Amendment to Corrective Action Plan for Interim Groundwater Treatment System Former American Beryllium Company Site OGC #04-1328
Tallevast, Manatee County, Florida

Lockheed Martin Corporation (Lockheed Martin) submitted a Corrective Action Plan for the Interim Groundwater Treatment System on September 19, 2008. We would like to amend the plan submitted to replace rather than repair the existing influent tank/containment dike system and also add instrumentation to monitor for leaks in the dual containment piping between the building and the new double-wall tank. After further review, it was determined that there would be significantly less impact to the site and surrounding community if we were to simply replace the existing system with a double-walled tank system. The use of a double-walled tank system will still allow the use of triple-redundant level switches/alarms for monitoring the primary tank level as well as the interstitial space between the inner and outer tanks, however, the specific types of switches will be slightly modified because the tank construction. The revised level monitoring approach is described below.

Design Drawings

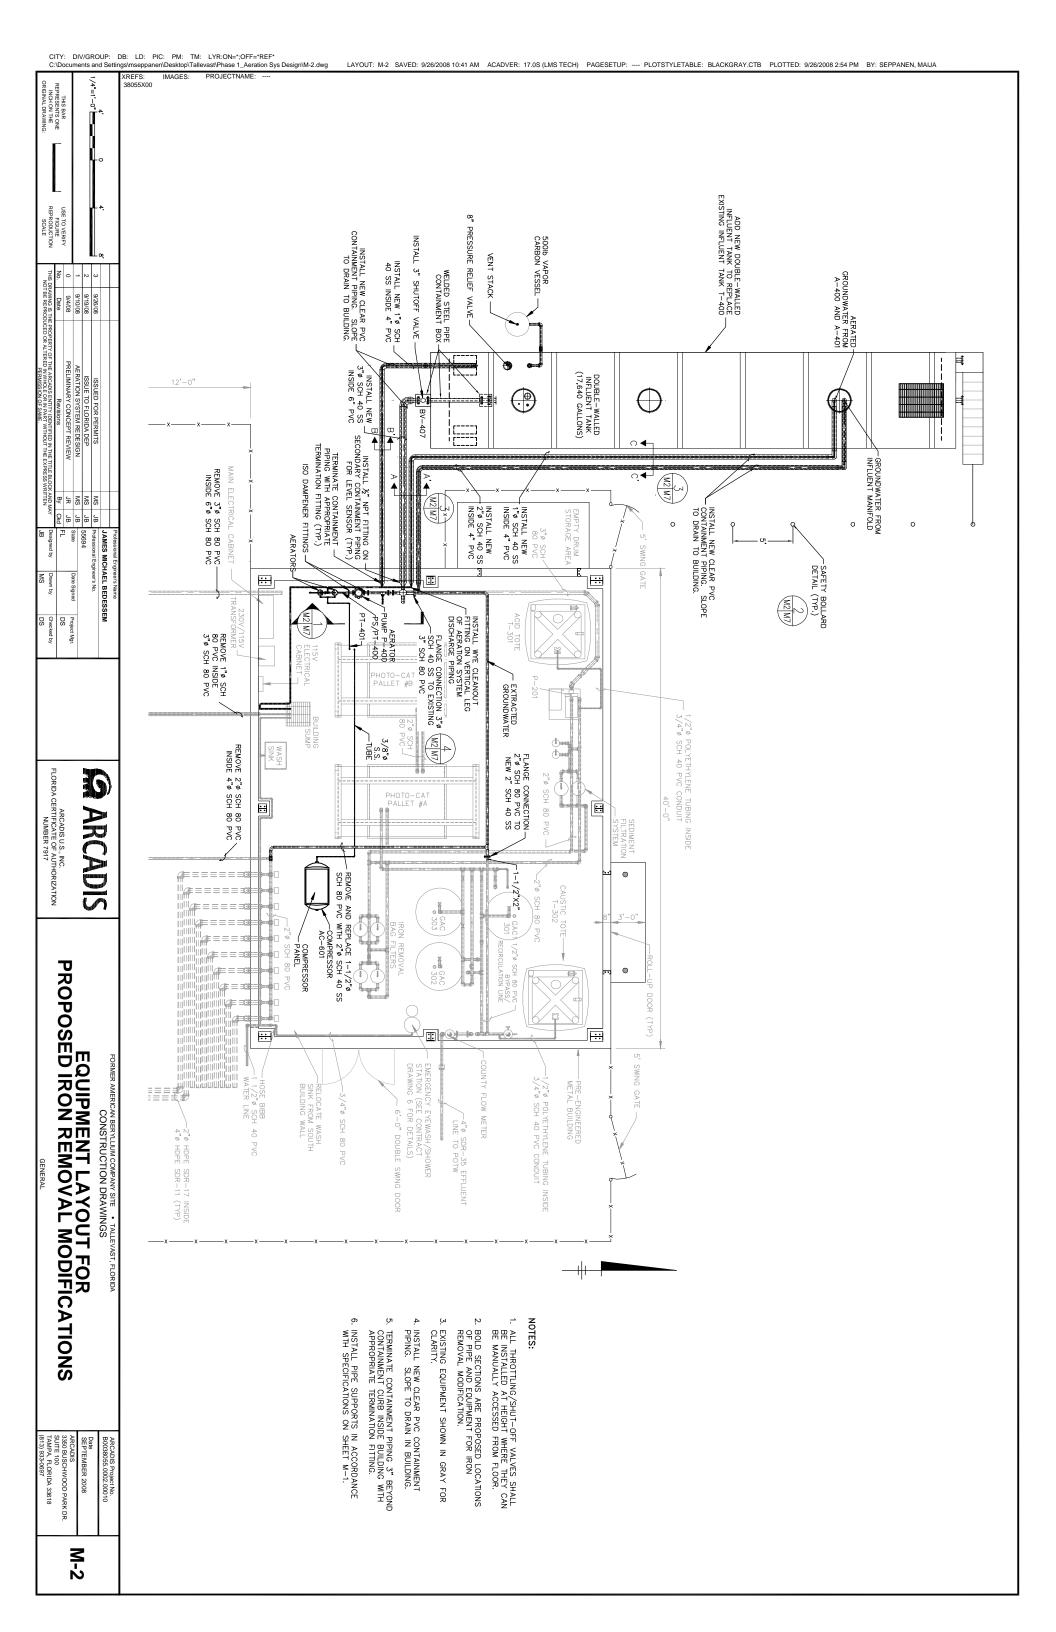
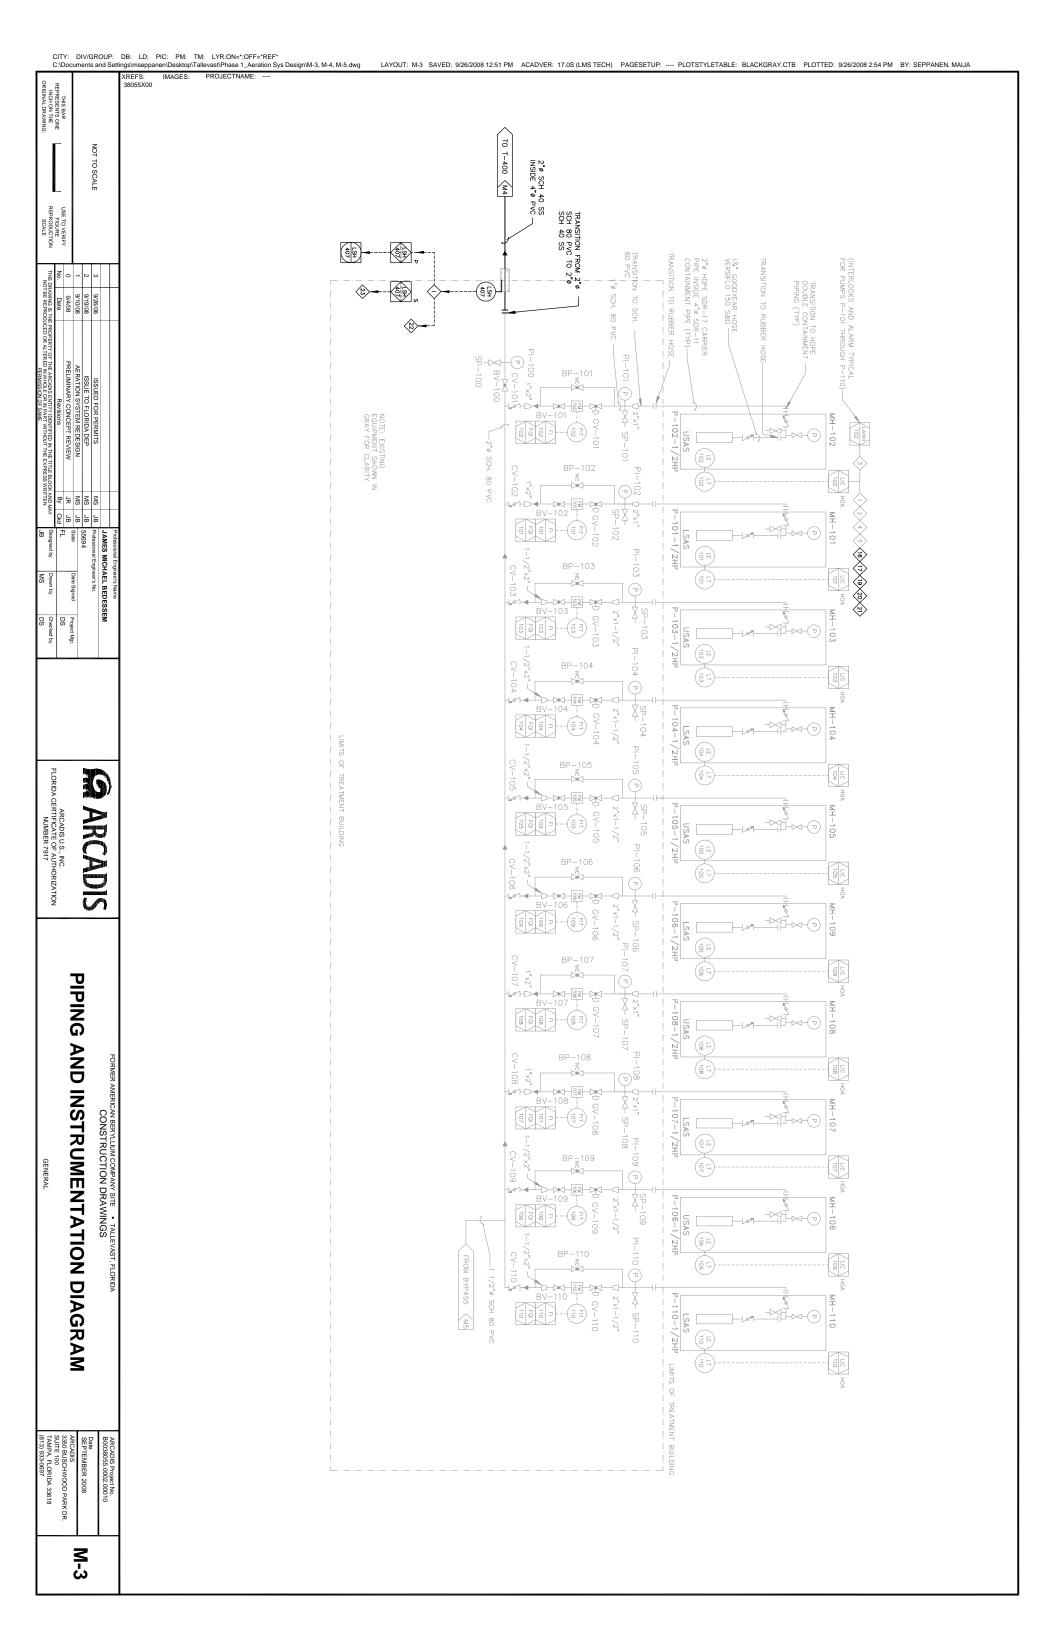
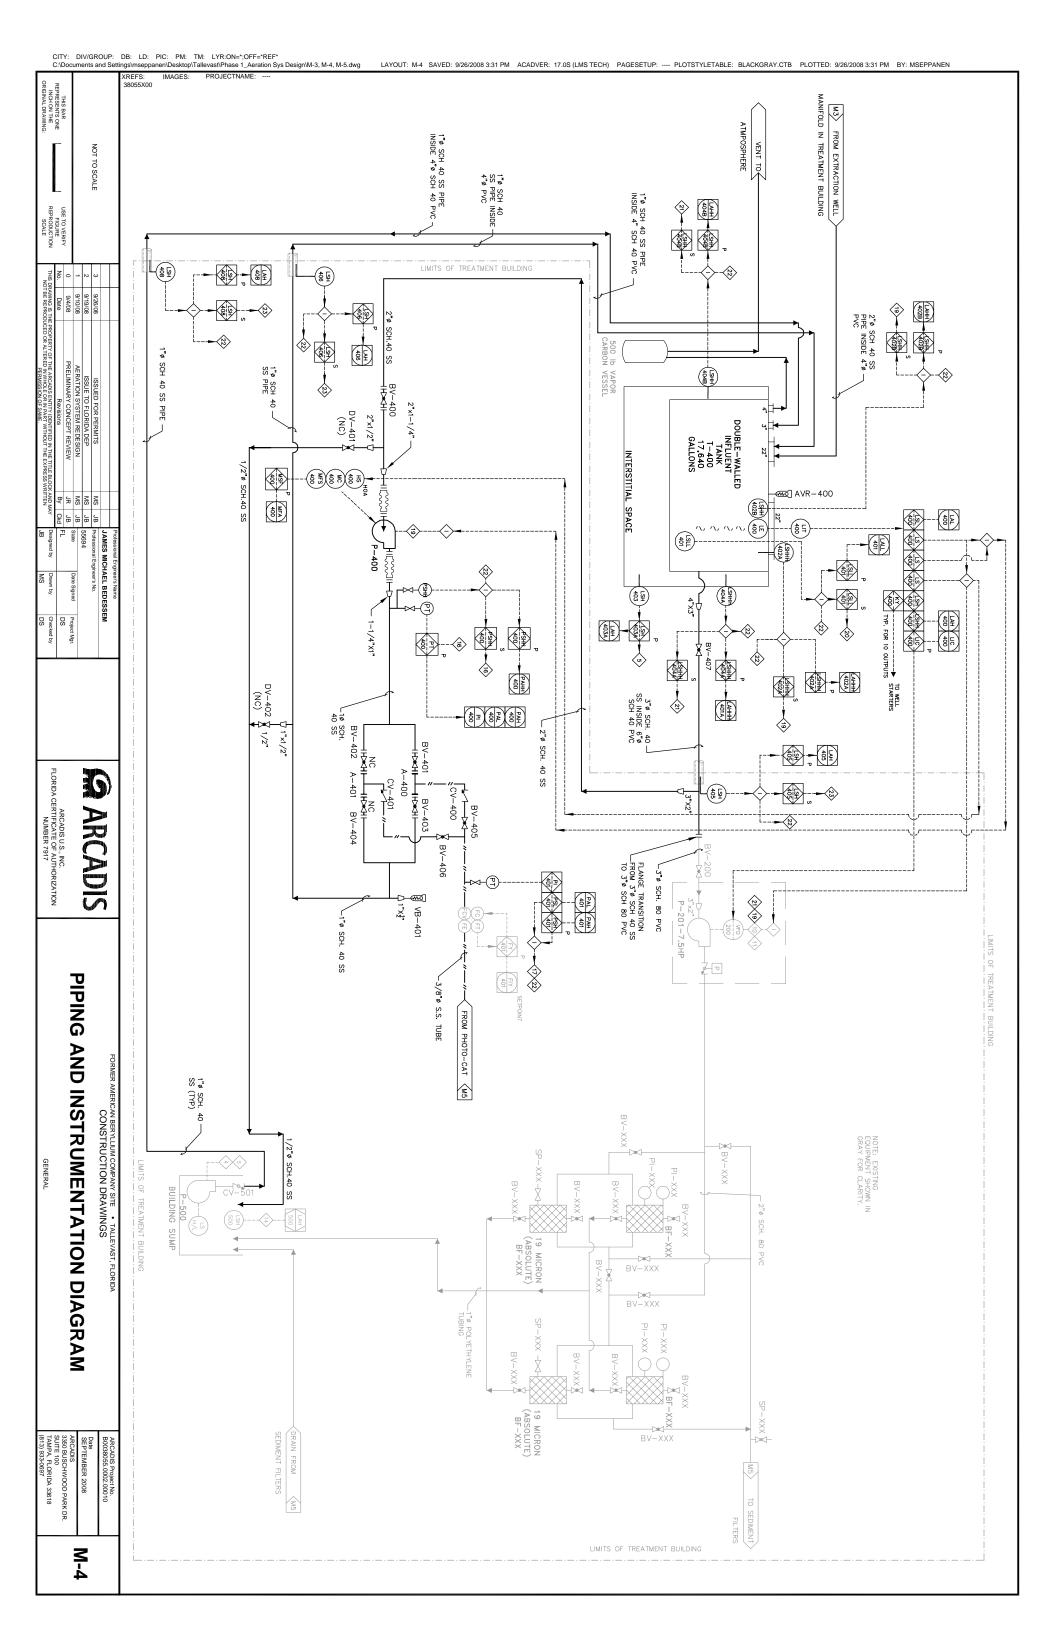
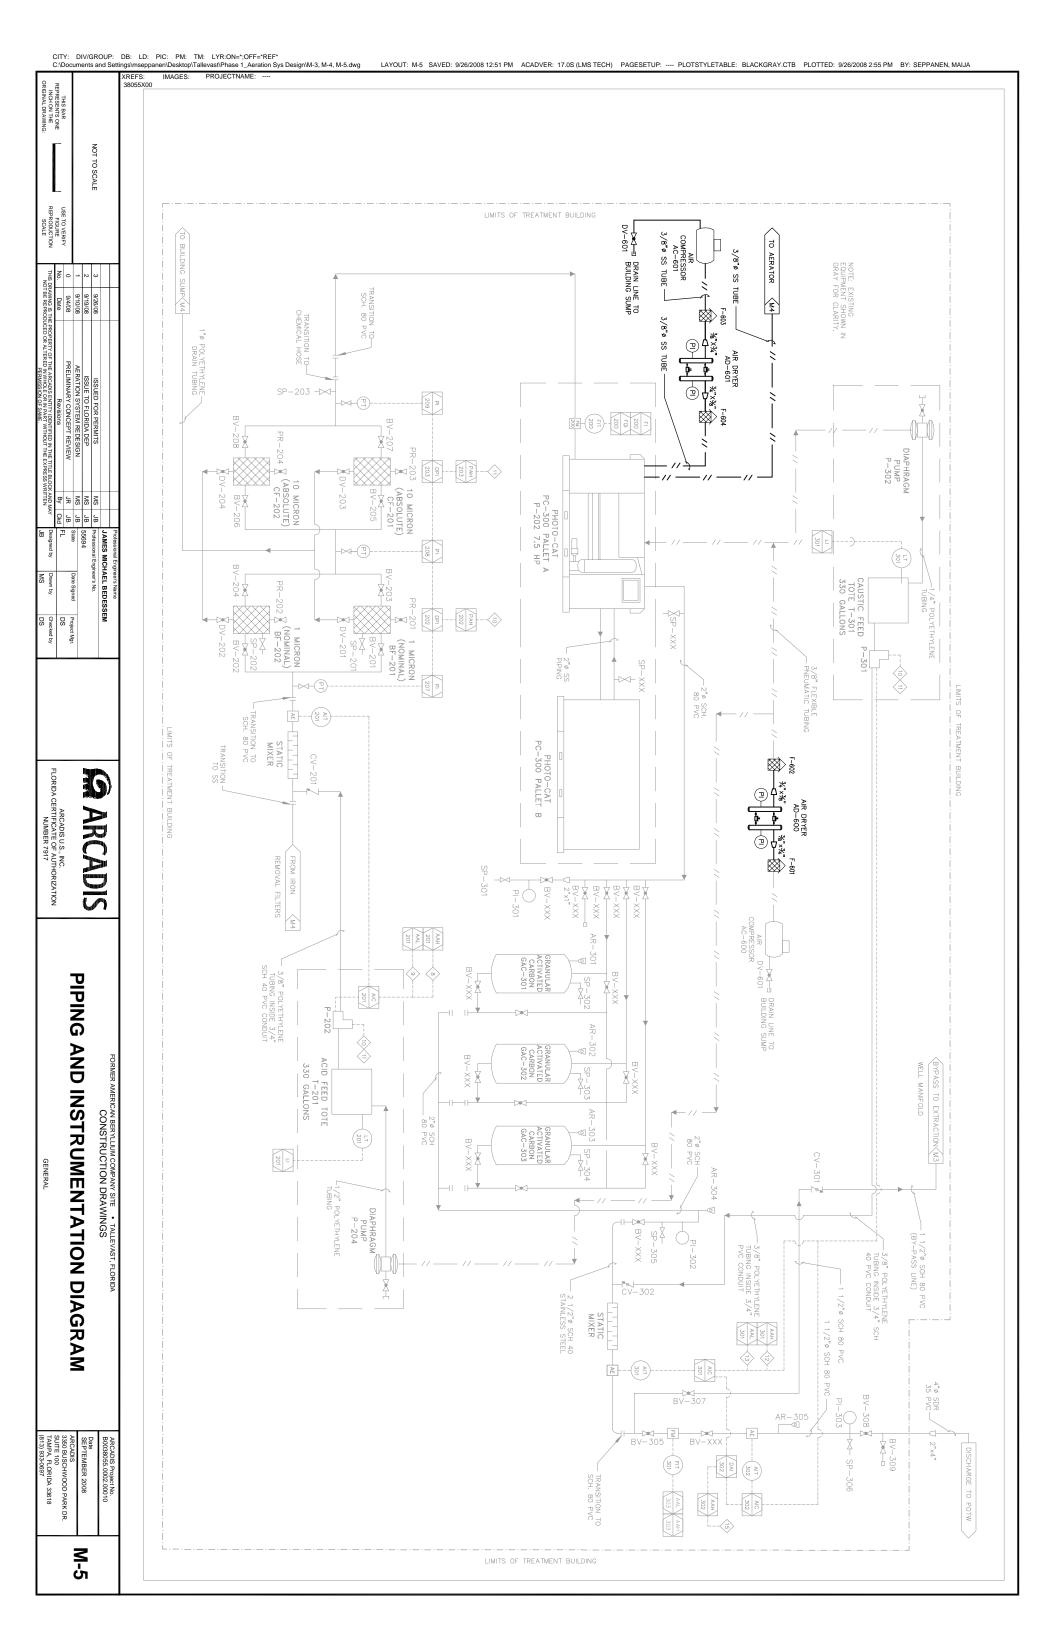
Instrumentation monitoring of the containment piping between the new double-wall influent tank and building will be done using conductivity switches. This will provide an additional factor of safety over visual monitoring of the containment piping. The drawing package has been revised to show the location of the new double-walled tank and process monitoring modifications. The drawings are provided in Attachment 1.

Groundwater pumped from the groundwater recovery system is initially discharged into a 20,000 gallon tank that sits inside a 22,000 gallon containment dike. The purpose of this tank is flow equalization, mixing of groundwater from the multiple recovery wells, and mixing of recovered groundwater with water saturated with oxygen for iron removal purposes. The tank has a passive vent used to regulate pressure as the tank is filled and drained. This air venting from this tank is treated using vapor—phase GAC. This influent tank/containment dike system will be replaced with a 17,640 gallon double—wall tank. be
